THE MIRASCOPE FOR A
RECTANGULAR C.R. TUBE
DNG. # 6 REVISED

EXPLAN ADDENDA, & COMMENTS

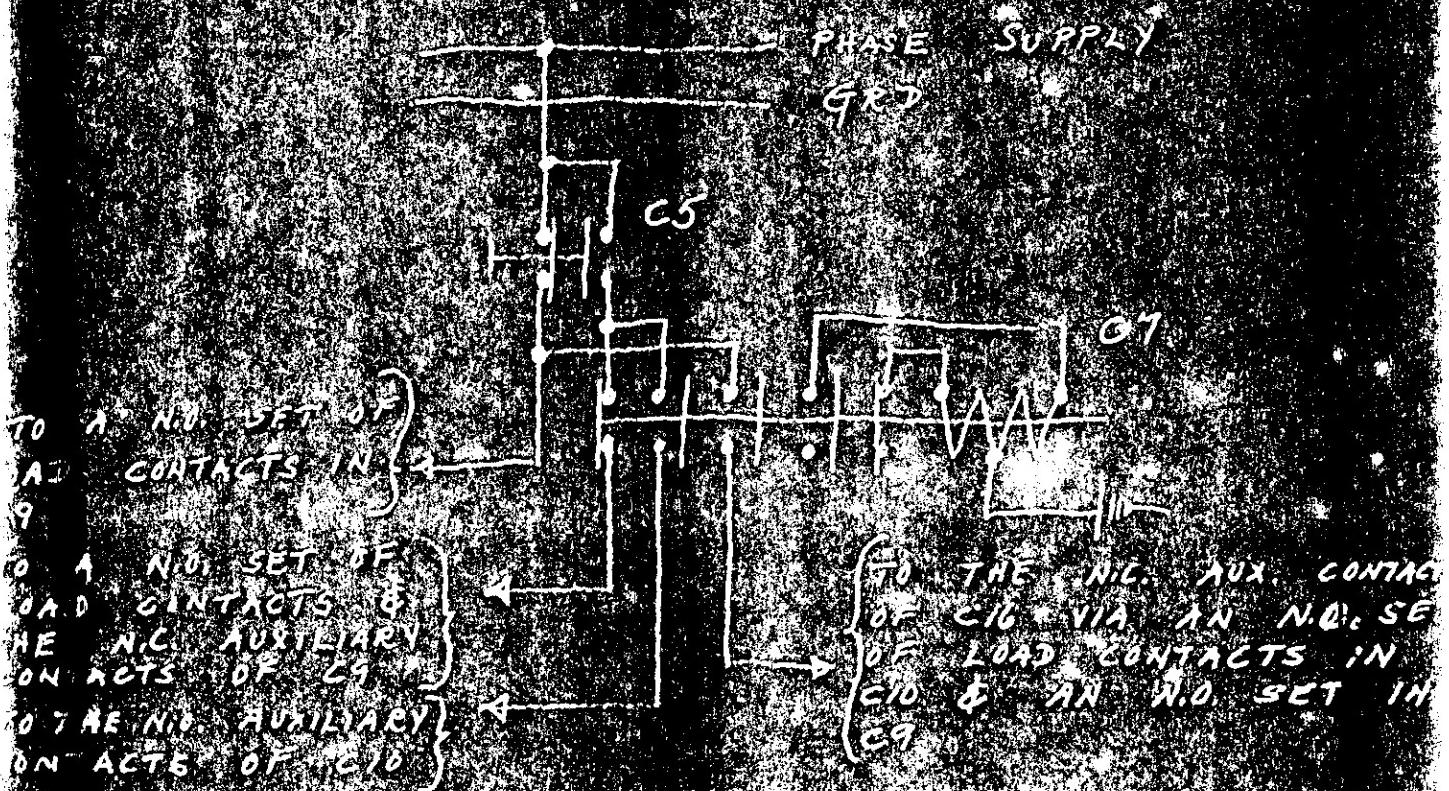
[NOTE - Click relay C9 on Dwg. #9. The set of contacts in C9, delivering open supply to the Drive Motor should be a normally-closed set of Dwg. #9 indicates otherwise, it should be revised in this regard.]

The microscope Control Circuit as given on Dwg. #9 differs from that given on the above-mentioned sheet #19 in the following principal respects:-

The addition of C16 to the circuit as per (a), has been for the purpose of providing for the disengagement of C6 and C8 after the re-alignment of the Domes for "black and white" viewing has been achieved. By so doing, any A.C. chatter associated with the continued engagement of C6 [the solenoid member of Position "A"] and C8 (the on-delay timing relay) is eliminated, and, further, any disturbing effects due to the continued feeding of the equipment items is eliminated.

Associated with the addition of C16 to the "black-and-white" alignment pattern of the control circuit are the above-noted changes in the specifications for C10 and C7 and, in part, the changes in the specifications for C9. From a reading of pages 901-911, it will be observed that

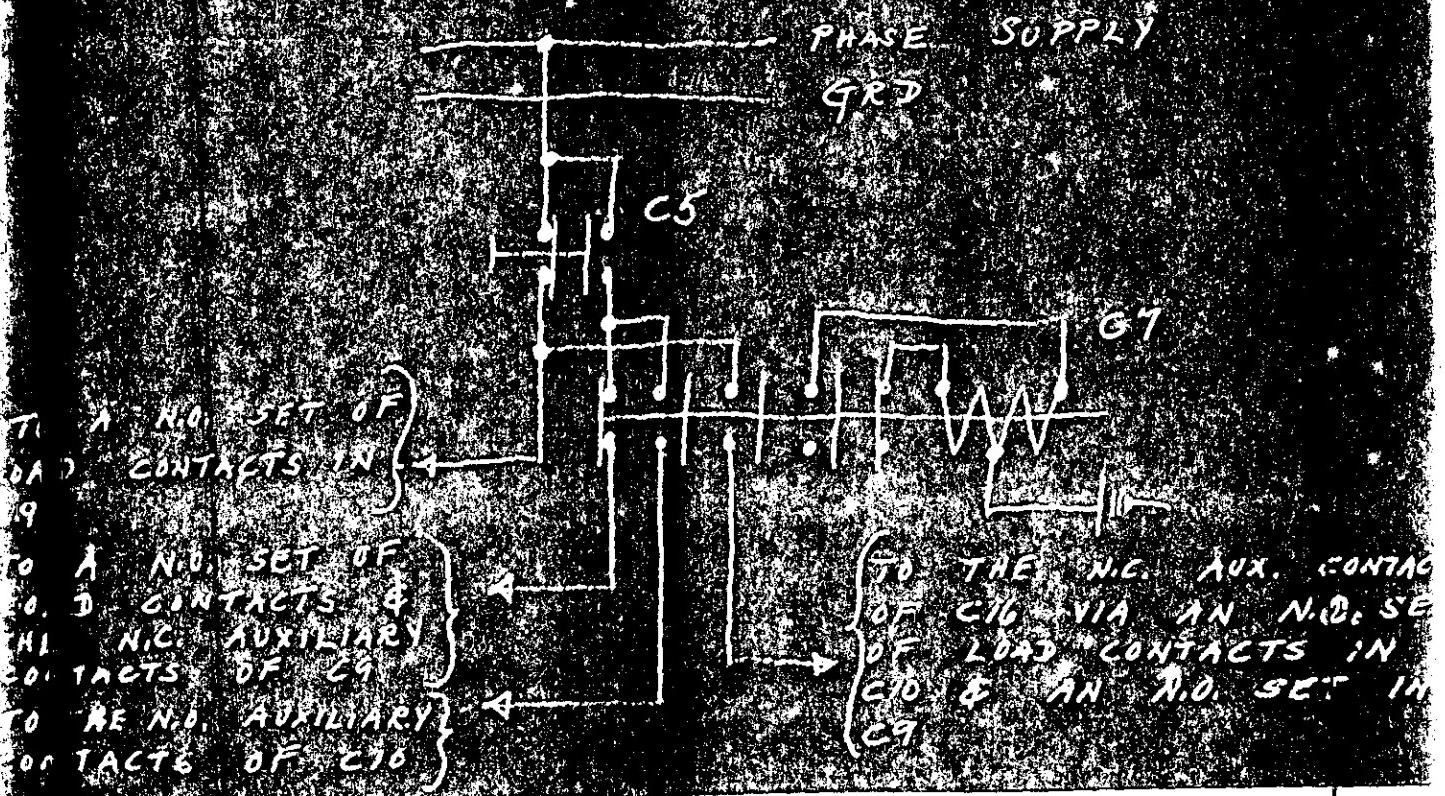
[NOTE:- Check relay C9 on Dwg. #9. The set of contacts in C9 delivering power supply to the Drive Motor should be a normally-closed set. If Dwg. #9 indicates otherwise, it should be revised in this regard.]

The "Mesoscope Control Circuit" as given on Dwg. #9 differs from that given on the above-mentioned sheet #19 in the following principal respects:-

The addition of C16 to the circuit as per (a) has been for the purpose of providing for the disengagement of C6 and C8 after the re-alignment of the Drsgs. for "black-and-white" viewing has been achieved. By so doing, any A.C. chatter associated with the continued engagement of C6 [the polaroid member of Positioner "A"] and C8 [the no-delay timing relay] is eliminated, and, further, any disturbing effects due to this a continued feeding of these equipment items is eliminated.

Associated with the addition of C16 to the "black-and-white" alignment section of the control circuit are the above-noted changes in the specifications for C10 and C7 and, in part, the changes in the specifications for C9. From a reading of pages 101 & 111, it will be observed that -

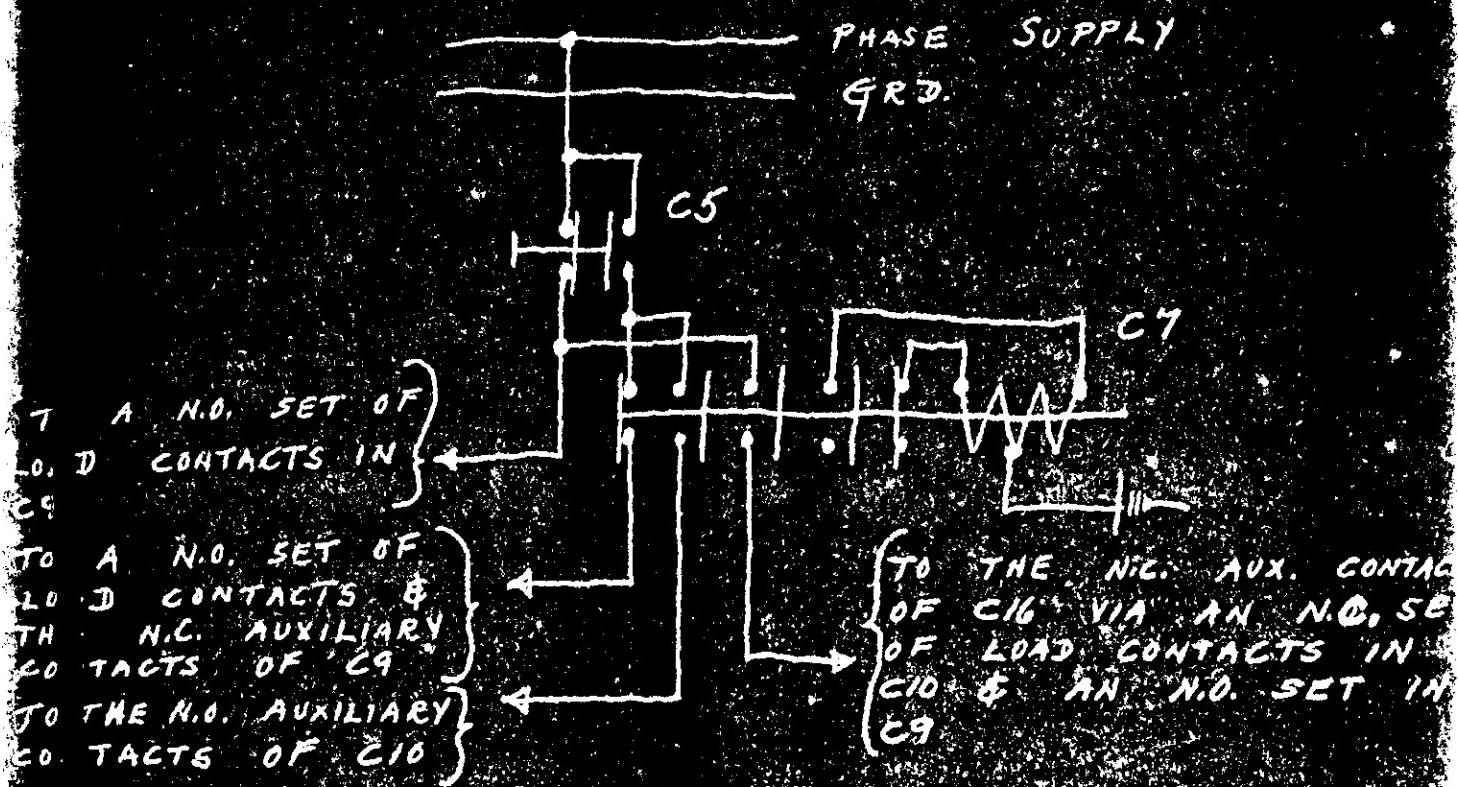
Since Pages 112-117 and Pages 201-210 were written, the following changes have been made in Dwg. #9:- a) C16 has been equipped with 2 N.C. contacts instead of one N.C. set; b) has been installed in the circuit; and, (c), C18 has been added to the circuit.

d) in correspondence to the above-mentioned equipment changes, certain details of the functional patterns have been altered.

The addition of C16 to the circuit as per (a) has been for the purpose of providing for the disengagement of C6 and C8 after the re-alignment of the Drums for "black-and-white" viewing has been achieved. By so doing, any A.C. chatter associated with the continued engagement of C6 [the solenoid member of Positioner "A"] and C8 [the on-delay timing relay] is eliminated; and, further, any disturbing effects due to ~~the~~ a continued feeding of these equipment items is eliminated.

Associated with the addition of C16 to the "black-and-white" alignment section of the control circuit are the above-noted change in the specifications for C10 and C7 and, in fact, the changes in the specifications for C9. From a reading of pages 101-111, it will be observed that:-

Fig. "C"

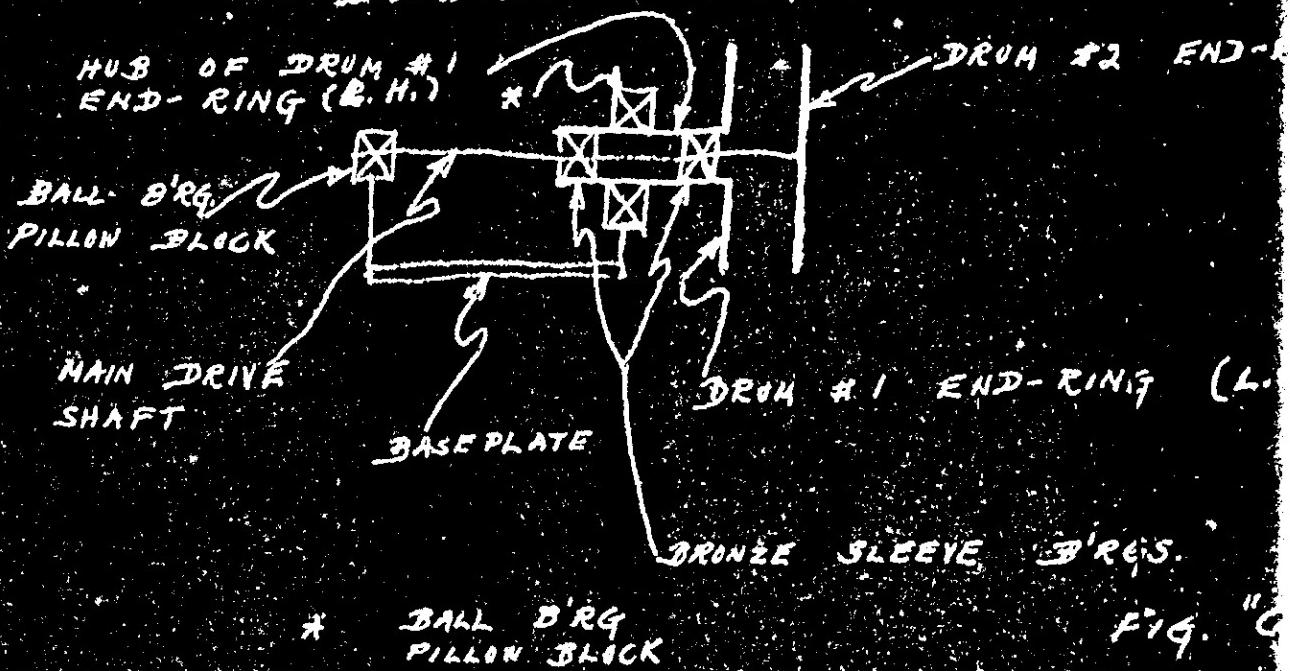
Observing Fig. "C", it is clear that the Bronze sleeves are a means of preserving a parallel alignment between two undrilled End-Rings. Once this is clear, it will be evident that if the thus-aligned rings are now adequately secured in an assembly the stable independence of the L.H. assembly is an established fact. The two ball-bearing block units provide the support for the assembly as a whole.

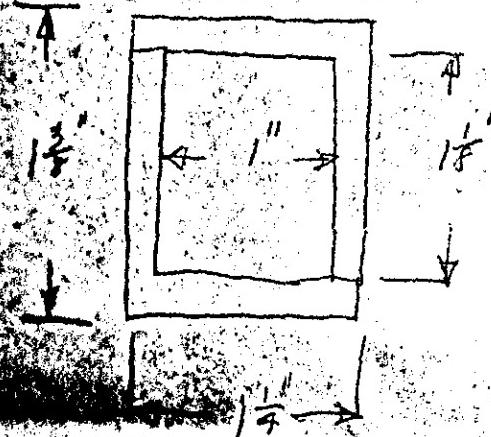
In other words, a tendency would exist for the loaded leg to flare out due to a result of the loading. This would be most noticeable in the case of the Outer Drum L.H. End-Ring. Then, in the next instance, in the case of Outer Drum R.H. End-Ring. It would be applicable to the Inner Drum End-Rings. If the load involved is such that if it concentrated over any single portion of a $1\frac{1}{4}'' \times 1\frac{1}{4}'' \times \frac{3}{8}$ produces an excessive deformation of the concentrated load. If tension stresses are concerned, there is but one way and that is to increase the area of the section. This is indicated some of the ways in which it can be done:-

* * * * *
 (In each case, the x-hatched area
 is the presently-specified $\frac{1}{2}$ -in.)

From purely structural considerations, (A) & (D) provide the soundest means of beefing up the stressed section. From a cost
